Item ID: D350-567-141 Accept ***N900040100*** Setup Start ***NS1***
 Revision ID: Stop ***NS2***
 Item Name: Floor Window Close Out
 Start Date: 12/7/2015 Start Qty: 2.00 ***2*** Cust Item ID:
 Required Date: 12/17/2015 Req'd Qty: 2.00 ***2*** Customer:
 Reference:

DART SERVICE INSTRUCTION

TO AMEND INSTALLATION INSTRUCTIONS D350-567 REV. E OR EARLIER
AND INSTRUCTIONS FOR CONTINUED AIRWORTHINESS ICA-D350-567 REV. 2 OR EARLIER

REF CANADIAN STC: SH92-18

Figure 1. Floor Window Close-out Kit Installation

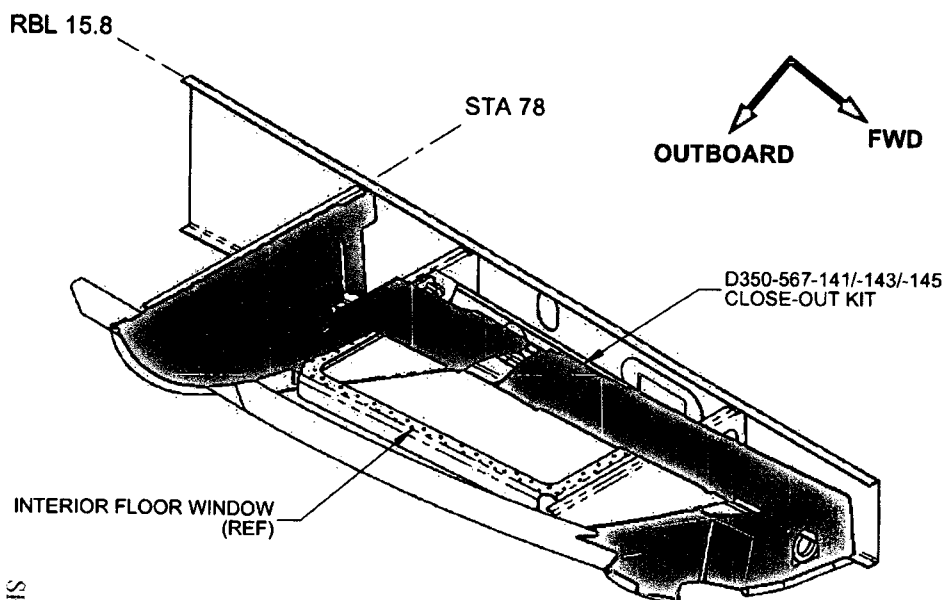
1.0 Purpose

The purpose of this service instruction is to add the D350-567-141/-143/-145 Close-out Kits, which are intended for customers wishing to operate their aircraft with the interior floor window removed. The D350-567-141/-143/-145 Floor Window Close-out Kits provide a barrier around the interior and exterior vertical reference floor window to prevent objects from falling into the aircraft controls when the interior floor window is removed as shown in Figure 1. The -143 Kit is identical to the -141 Kit with the exception of the D4971-041 T/R Bellcrank Cover Assy which replaces the D4435-045 T/R Bellcrank Cover Assy on aircraft fitted with energy attenuating seats. The -145 Kit is similar to the -143 Kit but is only kit compatible with the AS350 B3e aircraft.

Figure 13b. D4971-041/D4435-045 & D4434-047 Cover Installation
(D4434-047 is Optional on -141)

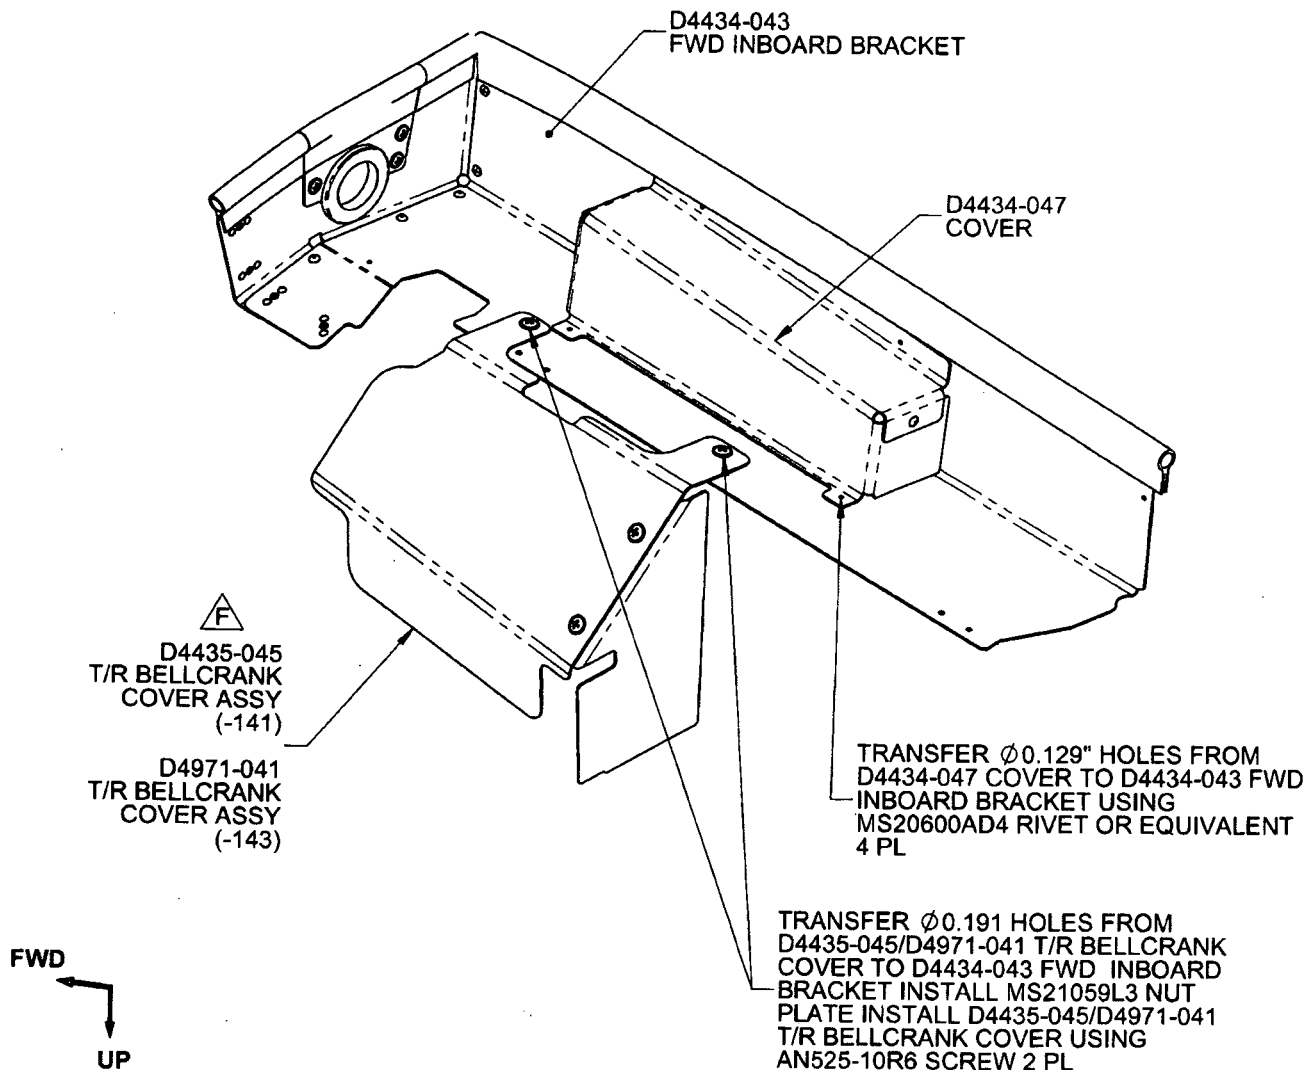
F	ADDED D4434-047 TO -141 KIT SEE PAR14-372.	AJS	15.01.12
E	ADD -143/-145 KITS	RF	14.03.20
E	CLARIFY FIGURES 3-12	VS	13.09.11
C	CORRECT TYPO NAS1149FN816P WAS NAS1149FN882P	RF	12.03.13
B	MS35206-229 WAS AN525-632R6; NAS1149FN616P (Qty 14) WAS (Qty 9); MS21042L06 (Qty 7) WAS (Qty 9); ADD AN525-832R7, NAS1149FN882P & MS21042L08	RF	12.02.22
A	NEW ISSUE	RF	12.01.09
REV.	DESCRIPTION	BY	DATE
DESIGN	RF	DART AEROSPACE LTD HAWKESBURY, ONTARIO, CANADA	
DRAWN	AJS		
CHECKED	B	DRAWING NO.	REV. F
MFG. APPR.	N/A	DSI 9590	SHEET 1 OF 19
APPROVED	AS	TITLE	SCALE
DE APPR.	TH	FLOOR WINDOW CLOSE-OUT KIT	NTS
DATE	15.01.12	COPYRIGHT © 2012 BY DART AEROSPACE LTD THIS DOCUMENT IS PRIVATE AND CONFIDENTIAL AND IS SUPPLIED ON THE EXPRESS CONDITION THAT IT IS NOT TO BE USED FOR ANY PURPOSE OR COPIED OR COMMUNICATED TO ANY OTHER PERSON WITHOUT WRITTEN PERMISSION FROM DART AEROSPACE LTD.

Figure 14. D4434-043 Fwd Inboard Bracket Cutout

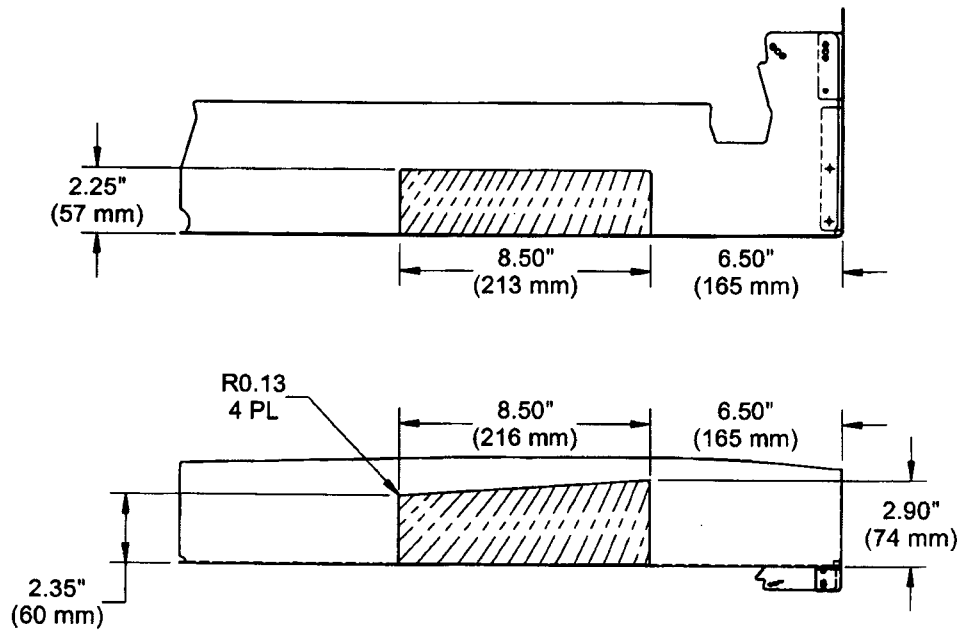
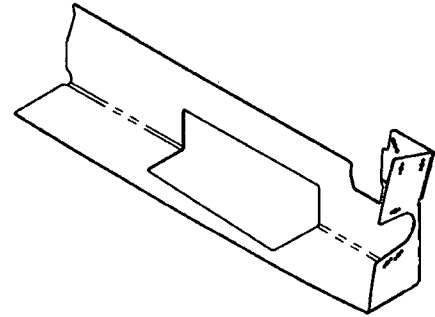
F 4.3 For -141 installations, if aircraft is equipped with Collective Circuit Breaker Board box, trim D4434-043 Fwd Inboard Bracket as shown in Figure 14. Note: Confirm the D4434-047 Bracket fits over the Collective Circuit Breaker Board box. Adjust opening as required.
